Halton District School Board

Addendum No. 4

RFT 26-030 Oakville #5 Elementary School & Child Care Facility

ADDENDUM NO. 4**Issued February 10, 2026**

SCALE: 1:20
PROJECT: 19001
DATE: FEB. 2019
DRAWING: S2.0
PRINT DATE: 2/6/2020 12:59:23 PM
REVIT FILE: 22261 - Hossack - Oakville 5 R22.RVT

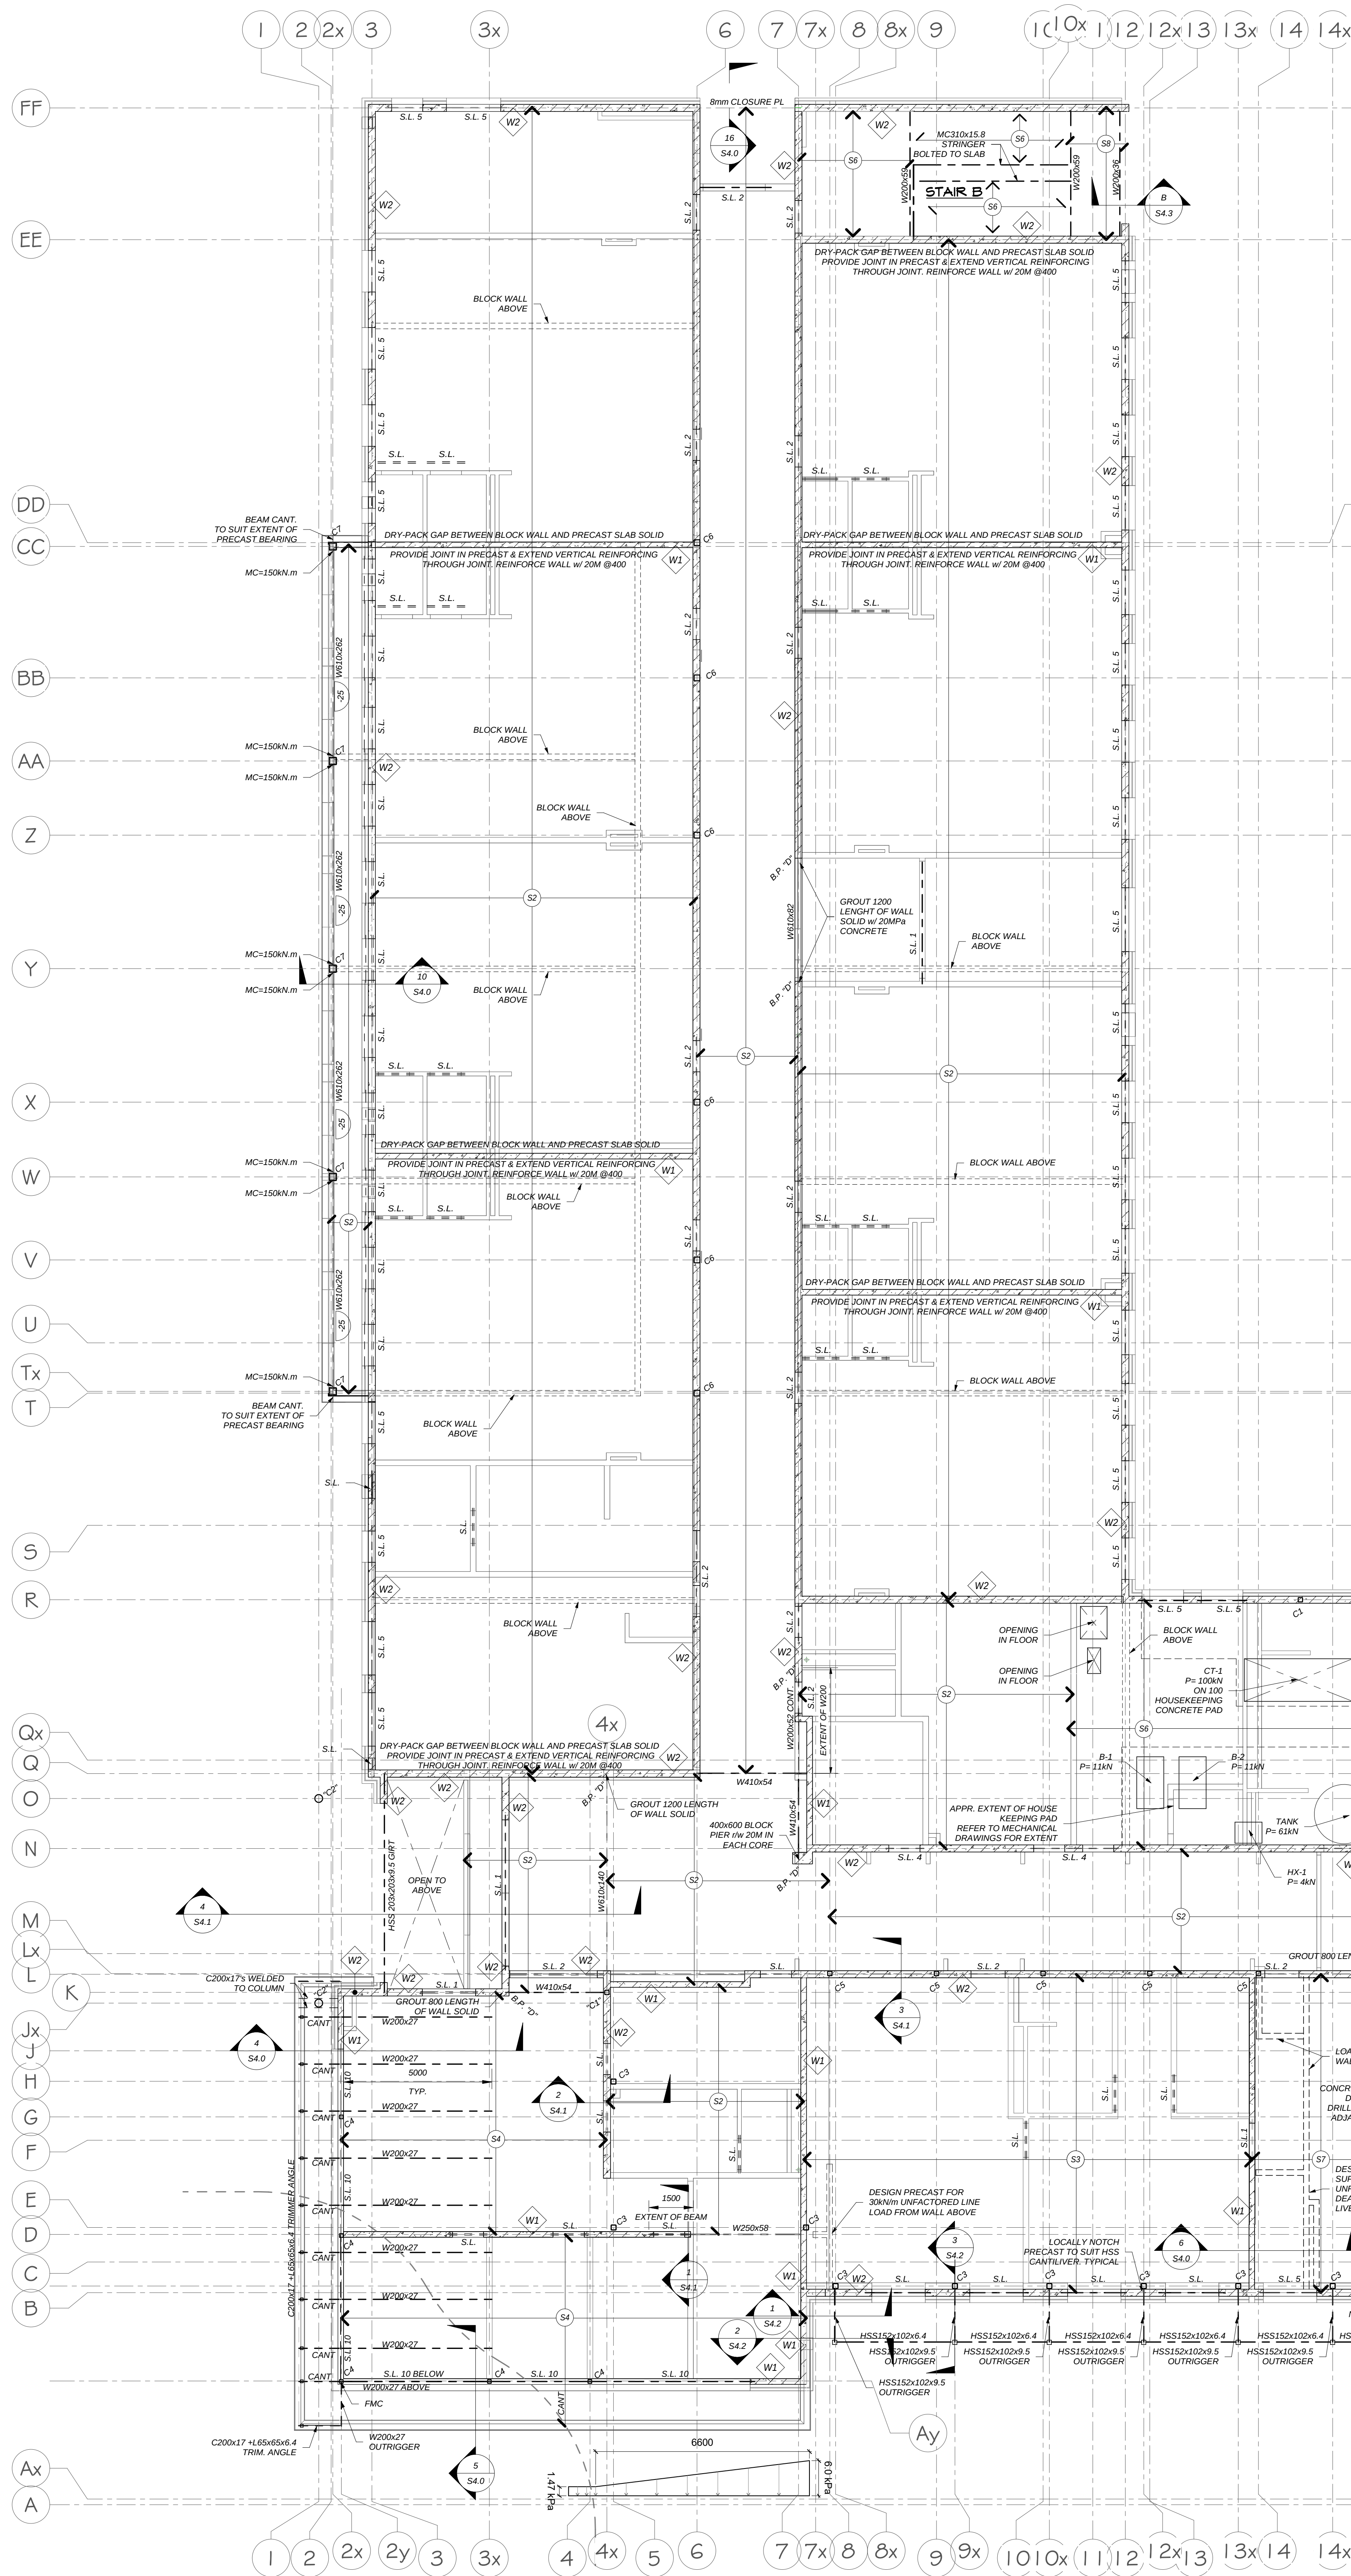
QUESTION 39: Drawing (1 / S2.0) – illustrates a section through the frost slab. This section does not provide adequate detail for the frost slabs. There is also no typical detail for the frost slabs. Please provide a detail for the frost slabs that indicates thickness of concrete and rebar required.

Question 2: *Drawing (1 / S2.0) – illustrates a section through the frost slab. This section does not provide adequate detail for the frost slabs. There is also no typical detail for the frost slabs. Please provide a detail for the frost slabs that indicates thickness of concrete and rebar required.*

ANSWER 39: Refer to revised drawing S2.0 attached.

Response 2: Refer to revised drawing S2.0 attached.
